UNITED STATES PATENT AND TRADEMARK OFFICE

Office Action Summary

10/674,906

The examiner acknowledges, as recommended in the MPEP, the applicant's submission of the amendment dated 12/28/04. At this point, claims 1, 11, 15, 16, 31, 33 have been amended. Claims 1-34 are pending in the instant application.

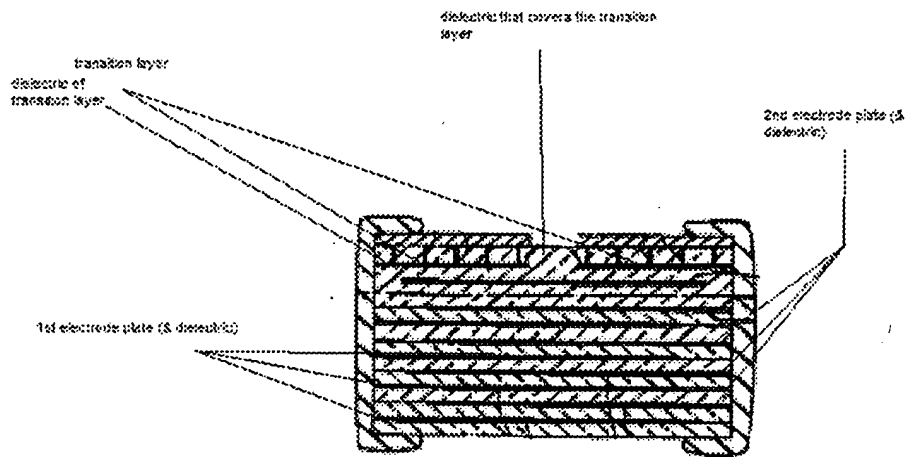
Devoe et al. disclose in fig. 9A, a multilayer electronic device, comprising: a plurality of dielectric layers; a plurality of electrode layers (10,11) interleaved with selected of said plurality of dielectric layers to form a multilayered arrangement, wherein each said electrode layer (10, 11) extends to and is exposed along at least one side surface of the multilayered arrangement; said multilayered arrangement defined by first

and second opposing surfaces and a plurality of side surfaces; at least one respective first (68) and second (66) transition layer electrode portion provided on the first surface of said multilayered arrangement; a cover layer (lower most ceramic layer) provided over said at least one respective first and second transition layer electrode portion, said cover layer formed to define a plurality of openings there through for exposing a portion of said at least one respective first and second transition layer electrode portions; at least one first peripheral termination formed along selected side surfaces of the multilayered arrangement and electrically connecting selected of said electrode layers and said at least one first transition layer electrode portion; and at least one second peripheral termination formed along selected side surfaces of the multilayered arrangement and electrically connecting selected of said electrode layers and said at least one second transition layer electrode portion.

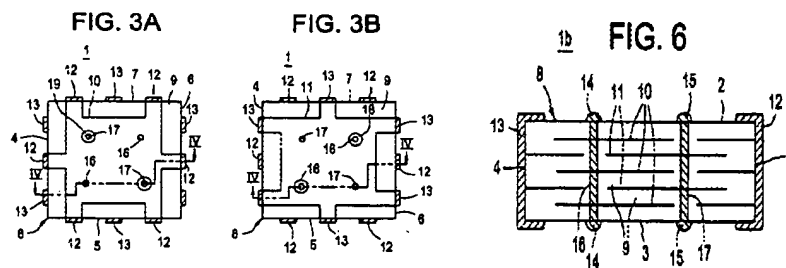
3. Claims 15-16 are rejected under 35 U.S.C. 102(e) as being anticipated by Kuroda et al. (US 6,594,136).

Kuroda et al. disclose in fig. 3A, 3B, 4, 9, a multilayer capacitor, comprising: a plurality of dielectric layers (9); respective pluralities of first (10) and second (11) electrode layers interleaved with selected of said plurality of dielectric layers to form a multilayered assembly, said multilayered assembly defined by topmost and bottommost layers and a plurality of adjacent side surfaces; at least one first via termination (16) provided through the topmost layer of said multilayered assembly and **electrically connected** to an electrode tab of one of said first electrode layers; at least one second (17) via termination provided through the topmost layer of said multilayered assembly and **electrically connected** to an electrode tab of one of said second electrode layers; at least one first peripheral termination (13) provided along selected side surfaces of said multilayered assembly and electrically connecting said plurality of first electrode layers; and at least one second peripheral termination (12) provided along selected side surfaces of said multilayered assembly and electrically connecting said plurality second electrode layers.

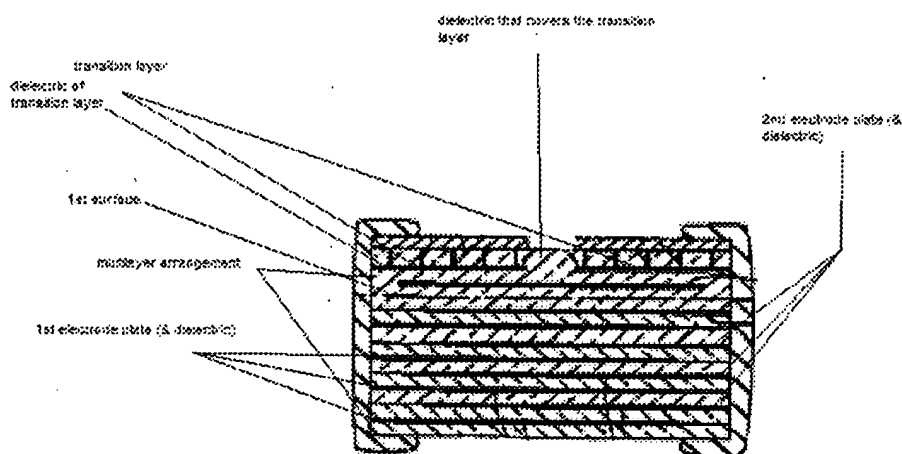
B) (Devoe et al. do not disclose providing first and second transition layer electrode portions on the first surface of the multilayered arrangement) The examiner does not agree (see illustration below). The transition layer is formed on the first surface of the multilayered arrangement.

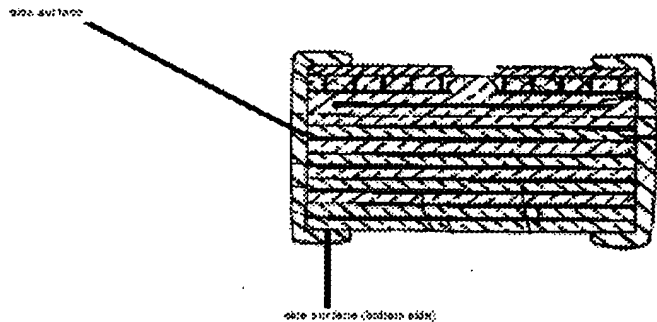
C) Devoe et al. do not disclose the at least one first and second peripheral terminations extend along an entire dimension of a respective selected side

surface of the multilayer device and wrap around to at least one side surface adjacent to the respective selected side surfaces. The examiner does not agree. Devoe et al. disclose the peripheral terminations extend along the entire left/right sides and wraps around the bottom side surfaces (see fig. below).
